## PUBLIC UTILITIES COMMISSION

## **Wildfire Safety Division's Revision Notice for Pacific Gas & Electric Company's 2021 Wildfire Mitigation Plan Update**

Figure 1: PG&E’s Reported VM Territory Cycle Expenditure

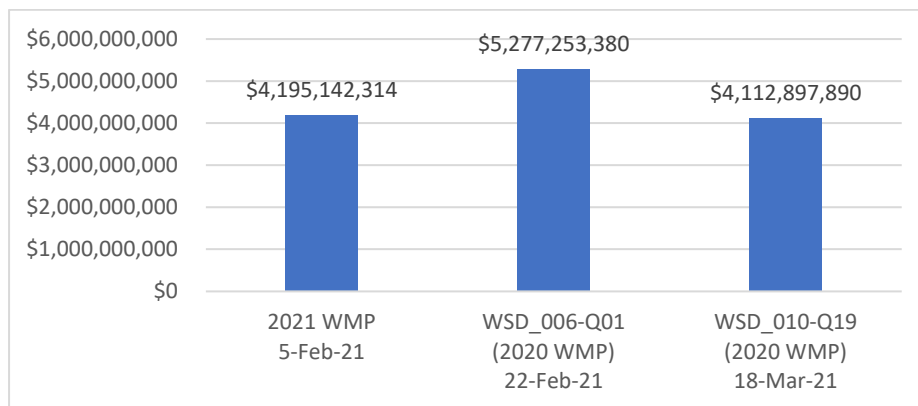
\$5,277,253,380,<sup>47</sup> and the VM HFTD Cycle expenditure was \$2,593,528,635.<sup>48</sup> The VM HFTD Cycle expenditure matches expenditure reported in PG&E’s First Quarterly report. However, VM Territory Cycle expenditure is reduced by \$1,082,111,066 relative to the 2021 WMP (see Figure 1).

On March 18, 2021, PG&E submitted “WildfireMitigationPlans\_DR\_WSD\_010-Q19Atch01.xlsx” in response to DR WSD\_010-Q19. In this response, PG&E reported the 2020 WMP VM Territory Cycle expenditure (as initially asked in WSD\_006-Q01) as \$4,112,897,890.<sup>49</sup> This value is \$1,164,355,491 less than previously reported in PG&E’s response to WSD\_006-Q01; *the WSD expects these figures to be the same, or very similar*. Variation in the VM Territory Cycle expenditure is illustrated by Figure 1.

Critical Issue No.	Critical Issue Title	Required Remedies
PGE-05	Unresolved Discrepancies in Vegetation Management Expenditure Data and their Effect on the Entire WMP	<ol style="list-style-type: none"> <li>1. PG&amp;E shall submit a revised Table 12 in the format of the attached Excel file named "PG&amp;E Revision Table 12 Template.xlsx." This includes:               <ol style="list-style-type: none"> <li>a. Annual expenditure, split by capital expenditure and operating expenditure, for each WMP initiative in HFTD and in its total territory (HFTD + non-HFTD), as forecasted in 2020 and reported in 2021;</li> <li>b. Columns K-AB require 2020 WMP forecasted expenditure for the 2020-2022 WMP cycle;</li> <li>c. Columns AC-AT require 2021 WMP Update forecasted expenditure for the 2020-2022 WMP cycle (actual expenditure for 2020 + forecasted expenditure for 2021 and 2022).</li> </ol> </li> <li>2. PG&amp;E shall explain in full and complete detail why the expenditure information in WSD-006-Q01 is so drastically different from previous submissions.</li> <li>3. PG&amp;E shall explain in full and complete detail what quality controls it has in place to ensure accurate and consistent reporting of expenditure.</li> <li>4. PG&amp;E shall explain in full and complete detail how it will ensure accuracy and consistency of the information contained within its future WMP submissions (particularly in relation to expenditure) going forward.</li> </ol>

Figure 2: PG&E’s 2020 Reported WMP VM HFTD Cycle Expenditure

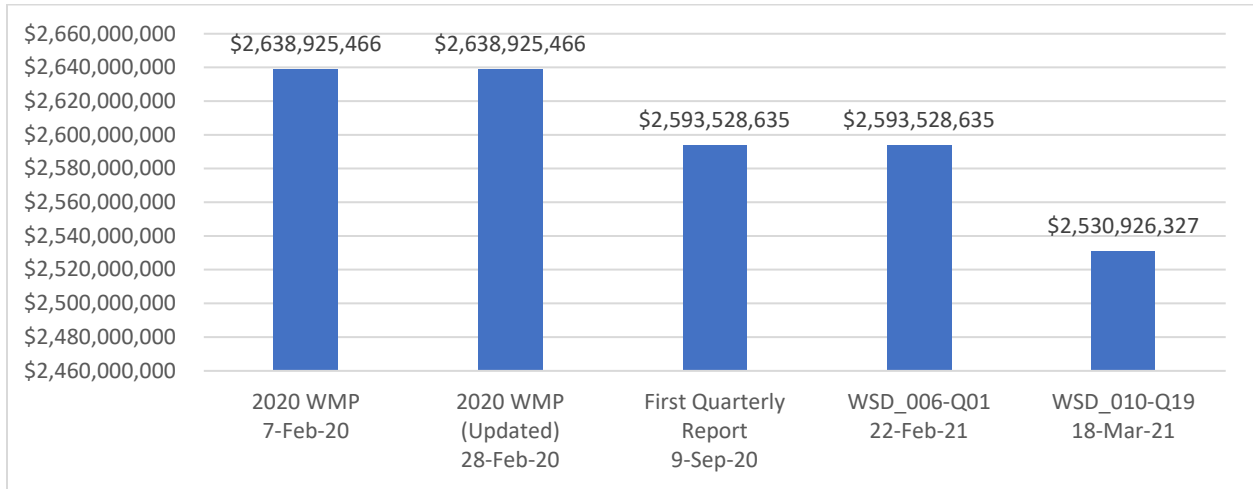
Similarly, in response to WSD\_010-Q19, PG&E reported the 2020 WMP VM HFTD Cycle expenditure as \$2,530,926,327.<sup>50</sup> This value is \$62,602,308 less than previously reported in PG&E’s response to WSD\_006-Q01 and less than every other prior submission mentioned in this analysis: *these figures should be the same*. Variation in the 2020 WMP VM HFTD Cycle expenditure is illustrated by Figure 2.

PG&E previously explained the difference in HFTD forecasted expenditure (Figure 2) between the 2020 WMP and the First Quarterly Report/ WSD\_006-Q01 in its response to Condition Guidance-5 (Class B) from Resolution WSD-002. The response to Condition Guidance-5 and explanation of the “updated spend” can be found in PG&E’s First Quarterly Report.<sup>51</sup> In the “Wildfire Safety Division Evaluation of Pacific Gas and Electric Company’s First Quarterly Report,” published January 8, 2021, the WSD found PG&E’s response to Condition Guidance-5 to be Sufficient.<sup>52</sup>

The new values submitted on March 18, 2021 as part of its response to DR WSD\_010-Q19 have not yet been justified by PG&E.
